Peach Bottom Atomic Power Station, Units 2 & 3
Facility Operating License Nos. DPR-44 and DPR-56
NRC Docket Nos. 50-277 and 50-278

Subject: Supplement to the Request for License Amendments Related to Application of Alternative Source Term, dated July 14, 2003

Exelon Responses to the NRC's Requests for Additional Information

PBAPS Arrangement Drawing A-9, Revision 11

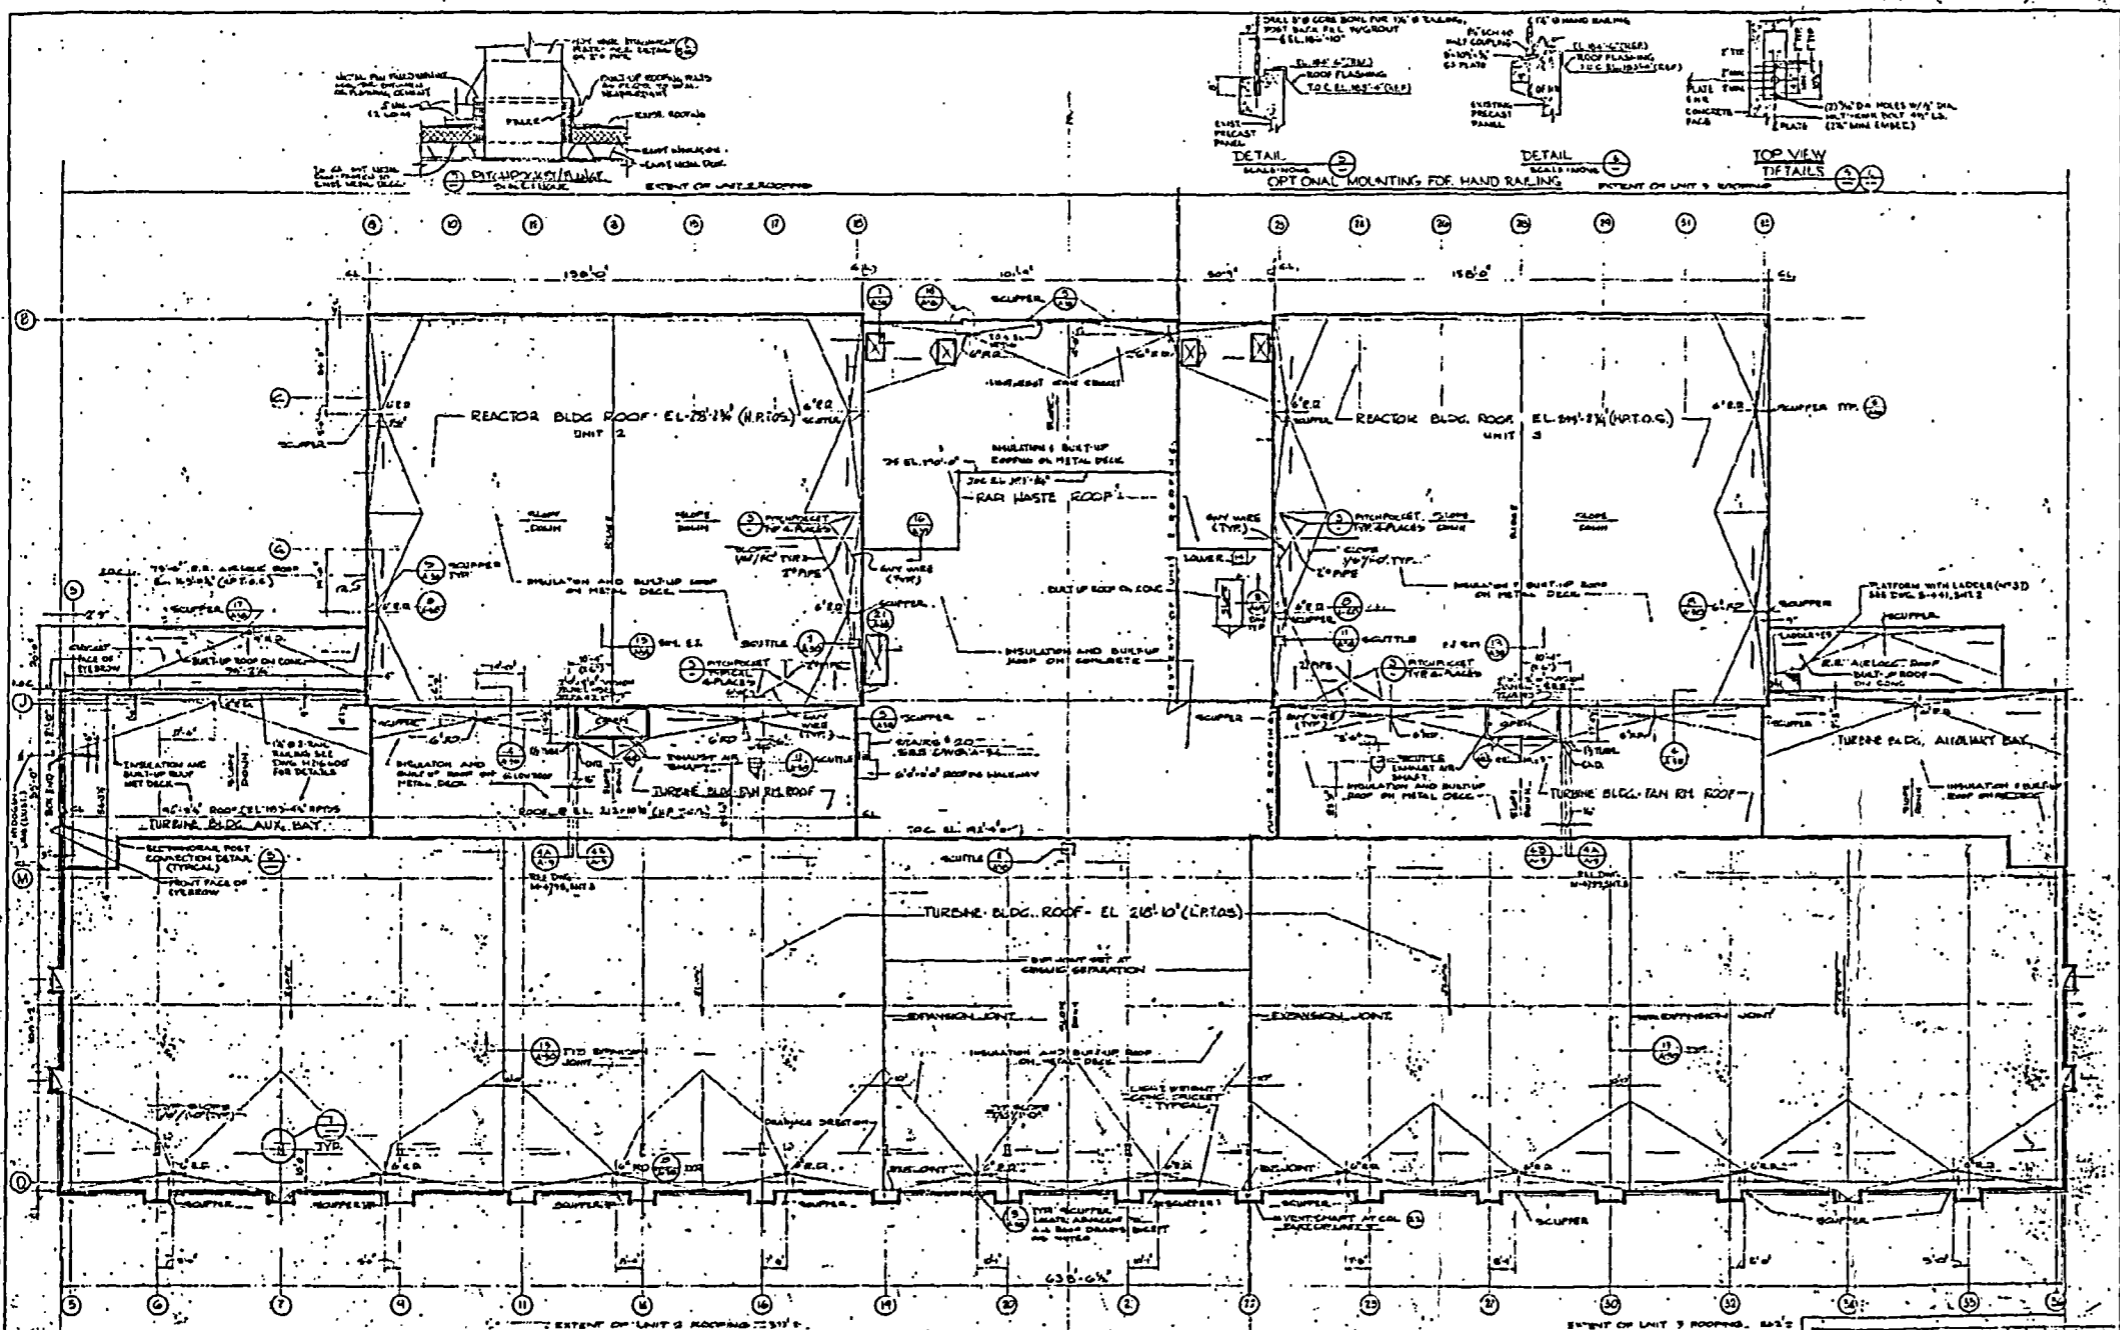
- d. The proposed change to Technical Specification 3.6.4.1 (Secondary Containment) will no longer require that the secondary containment be operable during the movement of fuel assemblies that have a decay period of at least 24 hours. The FHA analysis assumes the release to the control room intake and the environment is through the turbine building/reactor building (TB/RB) ventilation stack. Please justify that an FHA release through the TB/RB ventilation stack is an appropriately conservative assumption given that the secondary containment may be inoperable. Include general arrangement drawings in your response showing the potential release points.

As shown in general arrangement drawing M-7 (PBAPS UFSAR Figure 12.1.7), metal siding and a metal roof deck surround the elevations of the secondary containment above the refueling floor. However, as per PBAPS Specification 6280-A-9 for furnishing and installation of this metal siding, it can withstand without loss of air tightness a positive external wind pressure of 28 psf {5.4 in. WG}, a negative external wind pressure of 17 psf {3.3 in. WG}, or an internal pressurization to 37 psf {7.1 in WG}. The specification further requires testing of the reactor building in operation to verify maintenance of a minimum ¼ inch of water pressure. Therefore, FHA releases to the environment through the metal siding are not considered credible.

Figure 1: PBAPS Post-LOCA Containment Pressure

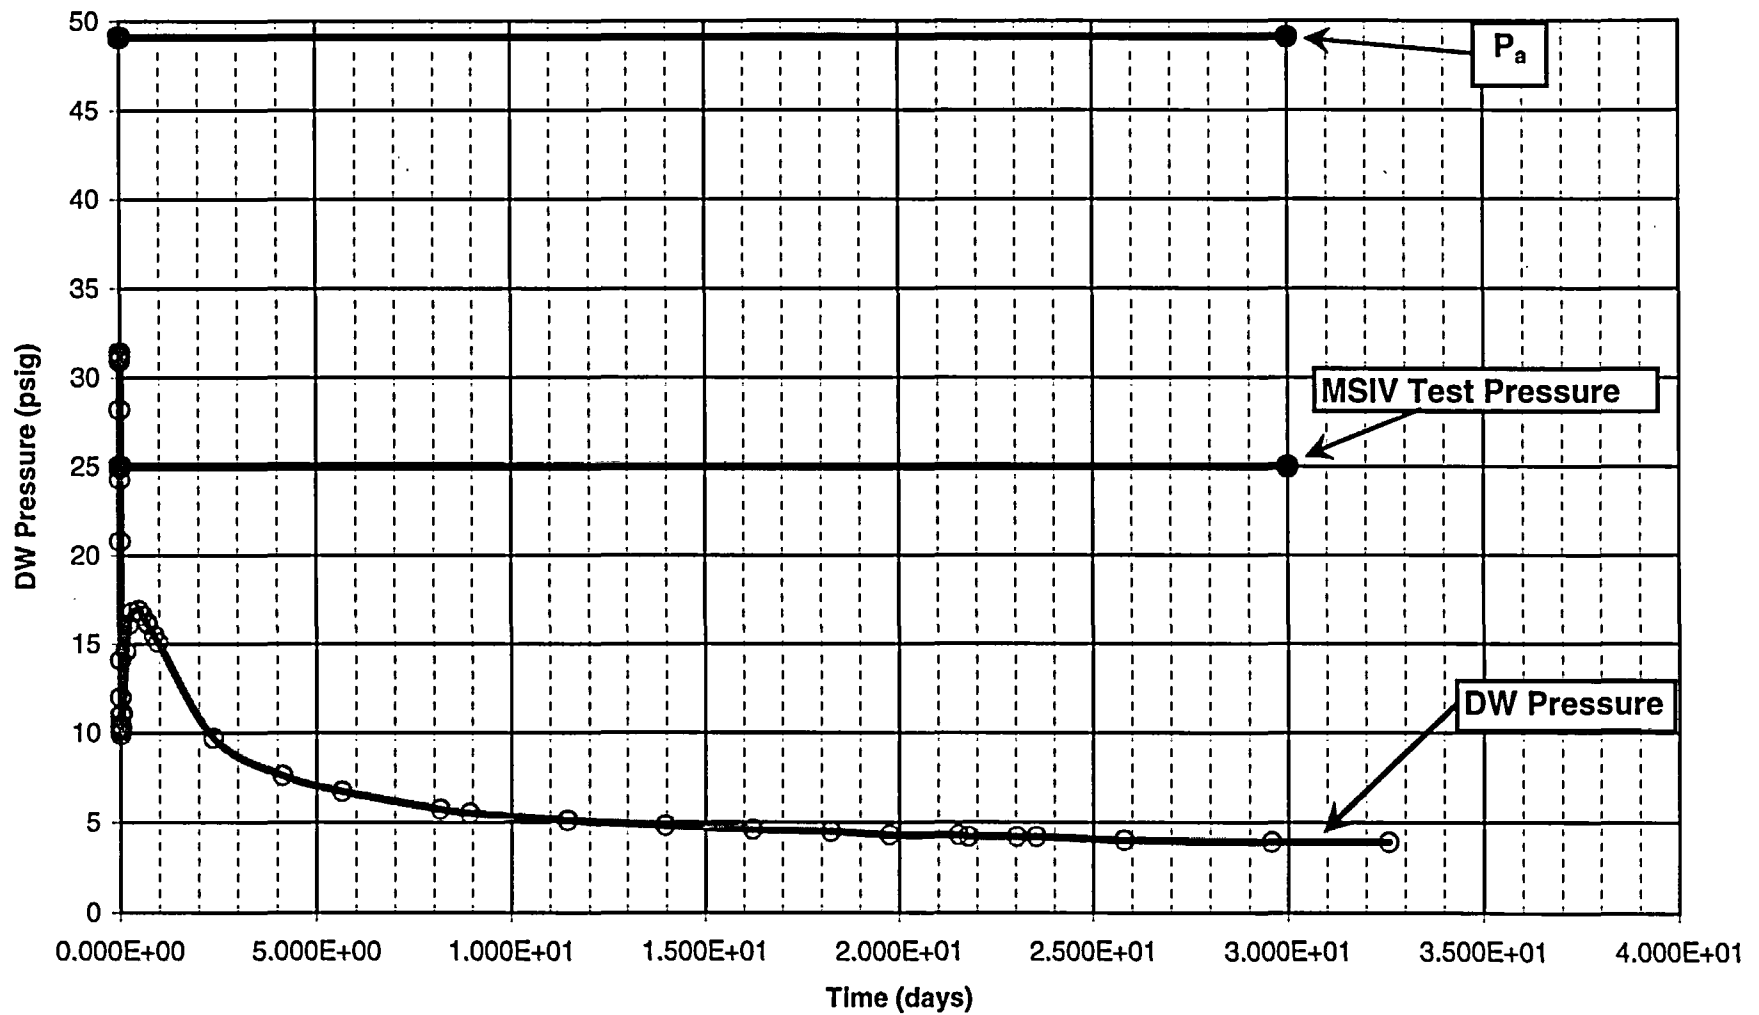
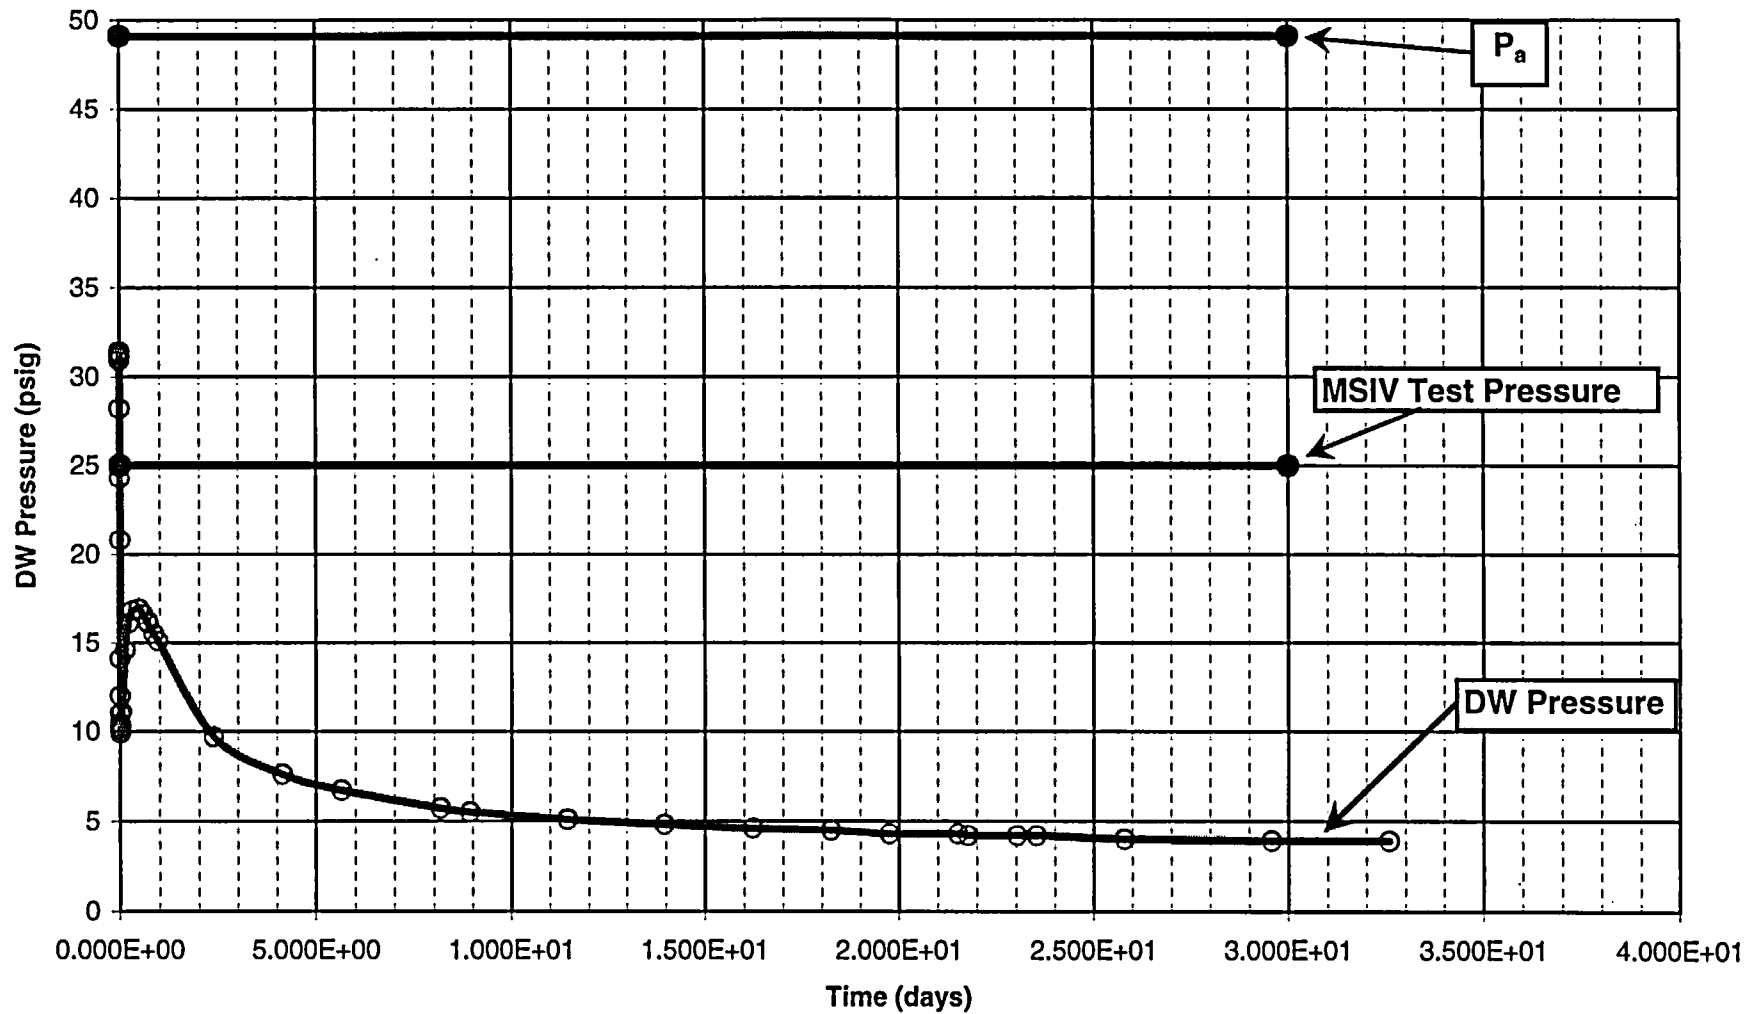
9. In Reference 2, Attachment 1, page 13, PBAPS states that an alternate method of evaluating leak rates is now being applied. The staff requests additional information regarding the methodology used to determine the predicted leak rate of 0.437 cfm in the maximum line at containment conditions. Please provide the calculations and assumptions used to determine this leak rate. For the leakage rates in each main steam isolation valve piping segment describe the method used to determine the flow rates.

RG 1.183 (Sections 3.7, and Appendix A Section 6.2) indicates that assumed containment leakage may be reduced after the first 24 hours, if supported by plant configuration and analyses, to a value not less than 50% of the technical specification leak rate. Attachment 3: [F1-Drywell Pressure Chart] shows the drywell pressure as a function of time and for comparison, the P_a and MSIV test pressures. Attachment 3: Leak Reduction Formulations shows that there are a variety of formulations that have been identified as potential predictors of leak rate ΔP dependence. For primary containment leakage other than MSIV, the worst case predictor was used to establish that leakage would be reduced to 56% of L_a at 24 hours and to 50% of L_a at 38 hours. MSIV leakage is calculated to be reduced to 77.2% of the technical specification value at 24 hours, 65.4% at 48 hours, 59.0% at 72 hours, 56.2% at 96 hours, and 50% at 275 hours, based on the worst case predictors, as

indicated in the Attachment 3: Drywell Pressure Data, and Attachment 4: Leak Reduction Assessment. Attachment 3: F2-Leak Rate Reduction illustrates how leak rates are conservatively modeled in comparison to as-conservatively-calculated values.

Sheet "F1-Drywell Pressure Chart" shows a comparison of post design basis LOCA analyzed drywell pressures, vs. leak rate test pressures for MSIV and other containment isolation valves. The pressure values are from Calc PM-1061, Rev 0, and are duplicated on Sheet "Drywell Pressure
